KEYSTONE XL PIPELINE PROJECT

0270-SD-P4-405-3-405.4-1

KEYSTONE XL PIPELINE PROJECT PIPELINE ROUTE VARIATION FORM			
1	<b>VARIATION TYPE:</b> Refinement: <input type="text"/> Reroute: <input checked="" type="checkbox"/> Footprint: <input type="text"/> Design: <input type="text"/> Centerline: <input checked="" type="checkbox"/> Pump Station: <input type="text"/> Valve Site: <input type="text"/> CAR: <input type="text"/>		
2	<b>LOCATION:</b> Sketch: <input type="text"/> Pictures: <input type="text"/> See attached State: <input type="text"/> SD County: <input type="text"/> Meade Quad Map: <input type="text"/> N/A Township: <input type="text"/> 09N Range: <input type="text"/> 14E Aerial Map: <input type="text"/> See attached map sheet Section: <input type="text"/> 13 Centerline: <input type="text"/> 3/14/2012 MP: <input type="text"/> 405.29 to <input type="text"/> 405.41		
3	<b>REASON FOR ROUTE VARIATION</b> (Please include reason for route variation): The primary reason for this reroute is to shift workspaces out and away of Cattle guard/fence. The reroute has been proposed based on a combination of Flyover video of Centerline, LIDAR data, Pictometry and other aeriels.

KEYSTONE PIPE

*Proposed Route Variation 0270-01*

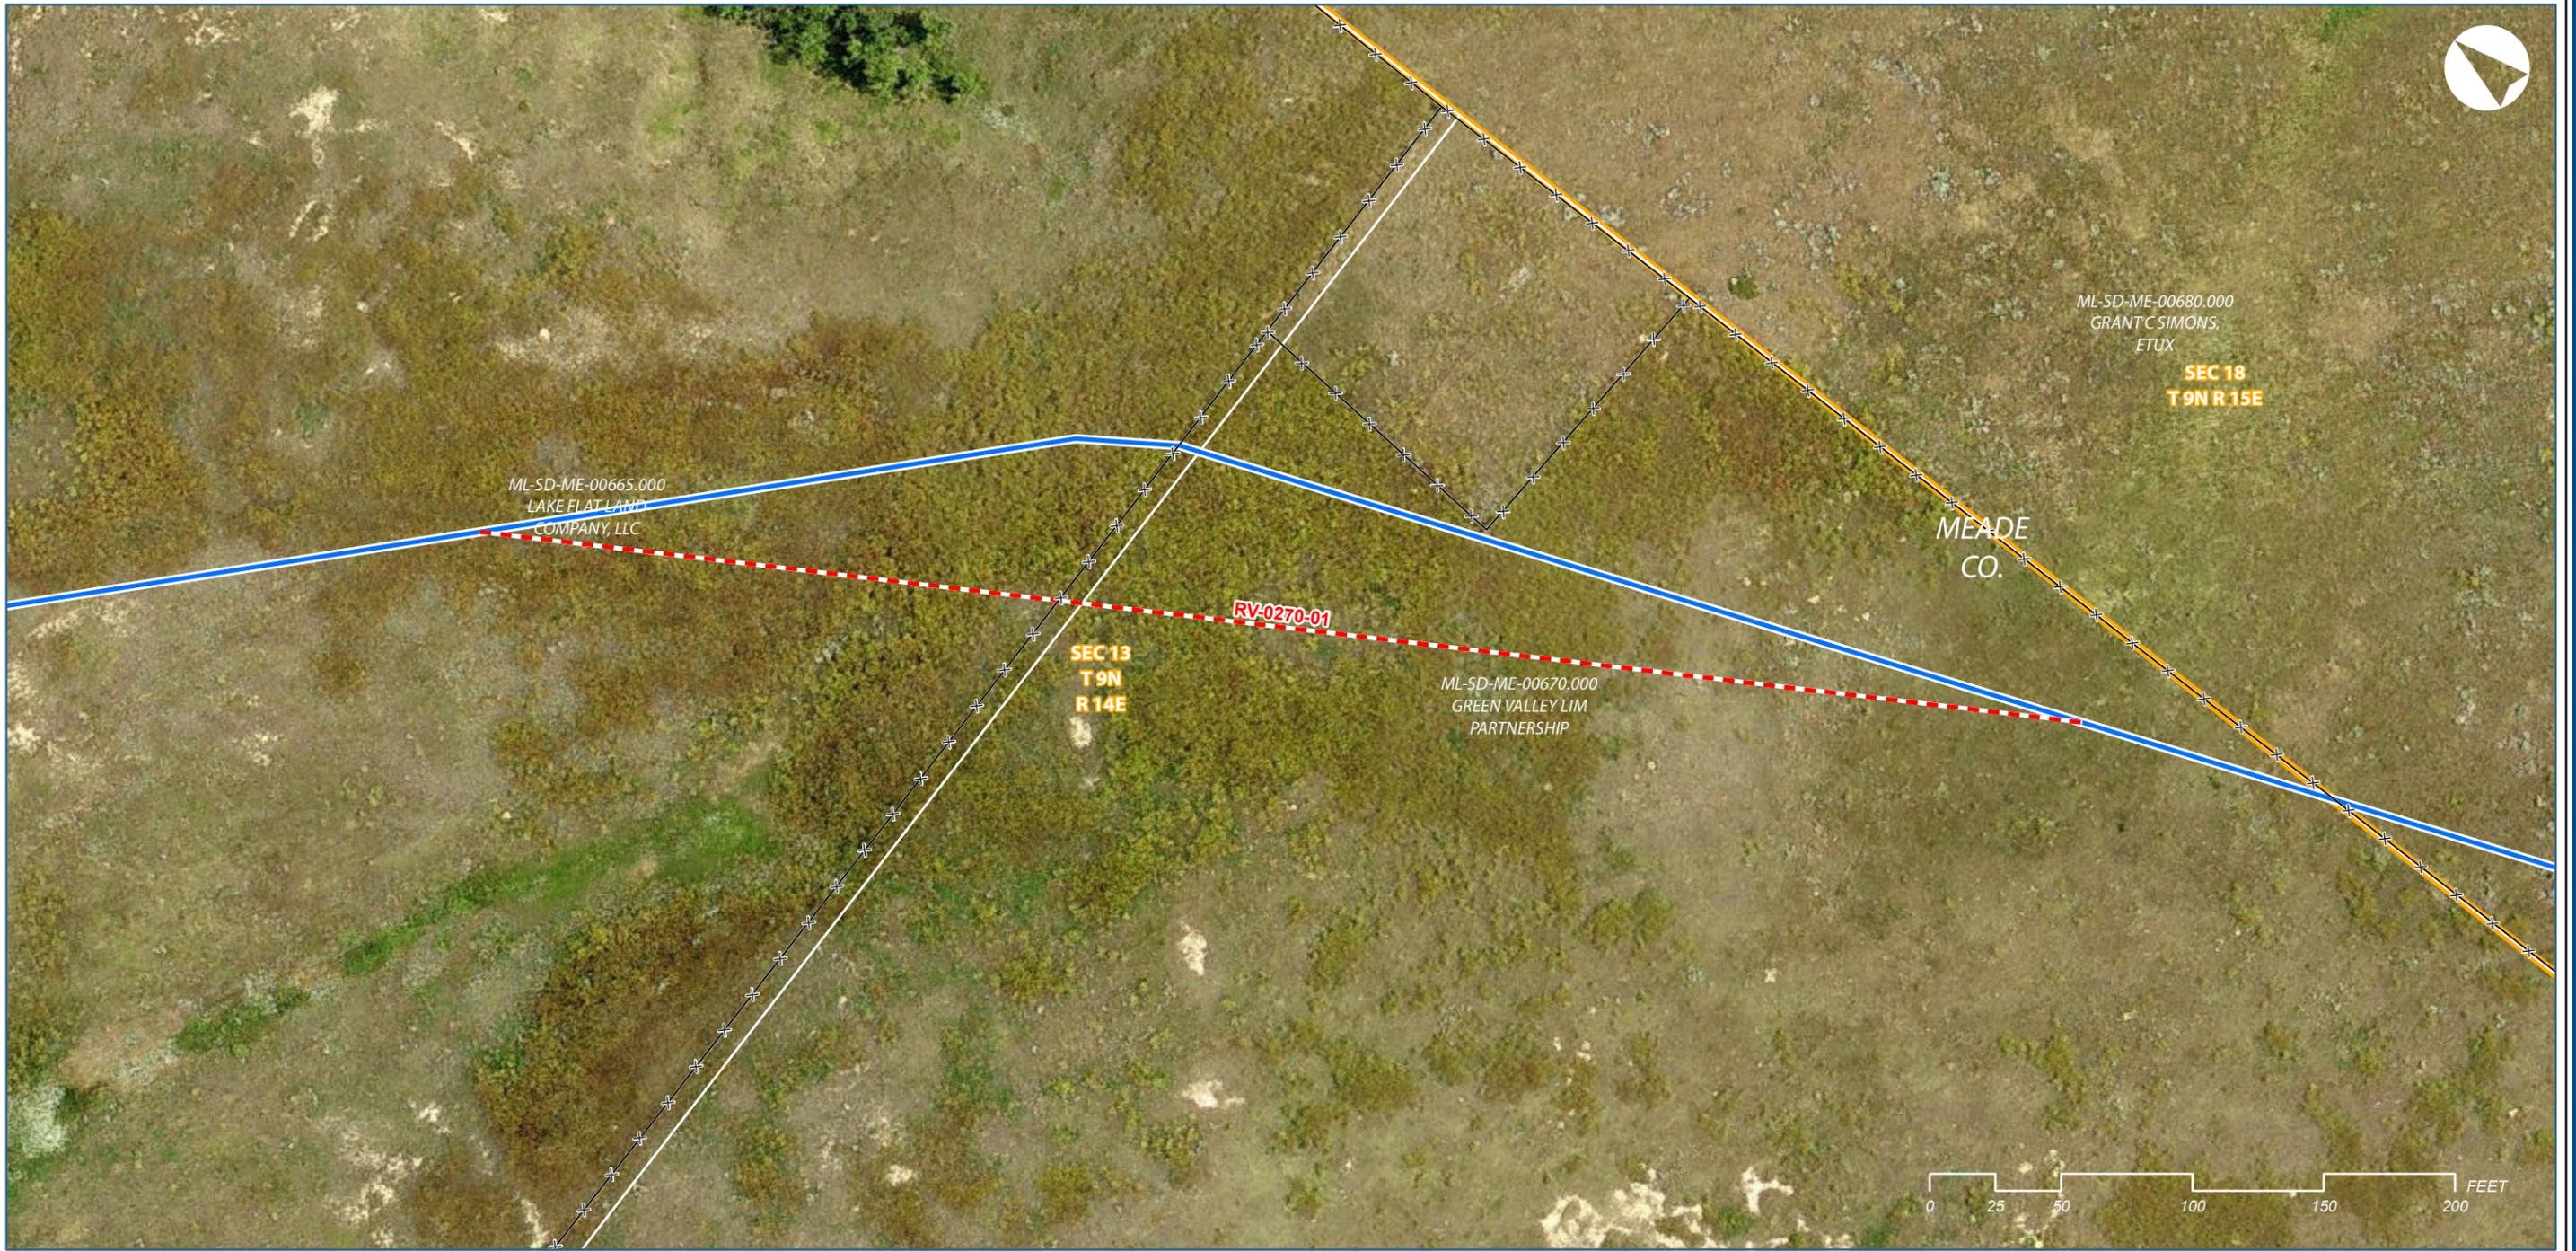
<b>DETAIL ROUTE VARIATION</b> (Please describe route variation in detail): Route variation starts near MP 405.3 and deviates ~15.5° west of current C/L. It extends in this direction for ~614 ft. before it rejoins the C/L near MP 405.4. The reroute allows ~45 ft. distance between the cattle fence and the CL.			
<b>ADDITIONAL IMPACTS</b> (Please include any additional impacts which may affect cost; crossings, induction bends, etc.): No New Landowners are impacted by this route variation. Two Tracts are impacted: ML-SD-ME-00665.000 (Lake Flat Land Company, LLC) ML-SD-ME-00670.000 (Green Valley Limited Partnership) This reroute is favorable to Landowner. The reroute decreases pipe length by ~15 ft.			
Is there an increase/decrease in the number of crossings? Yes <input checked="" type="checkbox"/> No <input type="checkbox"/> If yes, please list: <input type="text"/>			
<b>COST ANALYSIS</b> (costs incurred or saved from the route variation)
